Access Compliance Report Public Rights-of-Way (Curb Ramps)

Main Street: KYLE_CT Cross Street: KYLE_CT Location: S

ADA ID: RPRK211101115007 Ramp Type: Type 4 - Parallel Initial Pass/Fail: Fail Overall Compliance: No Severity Score: 15

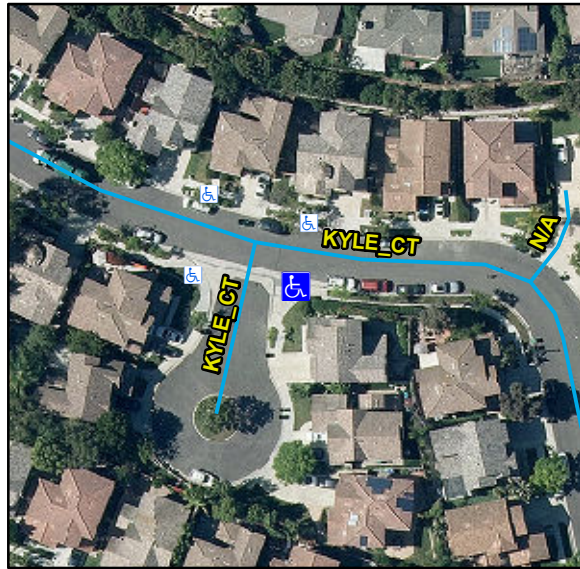
Compliance	Description	Data	Compliance	Description	Data
N/A	Ramp Length LT (in)	121	N/A	Ramp Length RT (in)	114
Yes	Ramp Width LT (in)	53	Yes	Ramp Width RT (in)	53
No	Ramp Run Slope LT (%)	9.4	Yes	Ramp Run Slope RT (%)	5.1
Yes	Ramp Cross Slope LT (%)	1.9	Yes	Ramp Cross Slope RT (%)	0.7
N/A	Landing Present	N/A	N/A	DWS Provided	N/A
N/A	Landing Length (in)	N/A	N/A	DWS Contrast	N/A
N/A	Landing Width (in)	N/A	N/A	DWS Length (in)	N/A
N/A	Landing Run Slope (%)	N/A	N/A	DWS Full Width	N/A
N/A	Landing Cross Slope (%)	N/A		DWS Offset Type	N/A
N/A	Landing Movement Obstructed?	N/A	N/A	DWS Offset Left (in)	N/A
	Landing Movement Type	N/A	N/A	DWS Offset Right (in)	N/A
N/A	Landing Shared	N/A			
N/A	Clear Space	Yes			
N/A	Clear Space To Crosswalk (in)	N/A			
N/A	Marked Crosswalk 1	No	N/A	Marked Crosswalk 2	No
	Crossing 1 Direction	NE		Crossing 2 Direction	NW
	Marked Crosswalk 1 Width (in)	N/A		Marked Crosswalk 2 Width (in)	N/A

Remove & Replace Curb Ramp With Two New Directional Ramps or Equivalent.
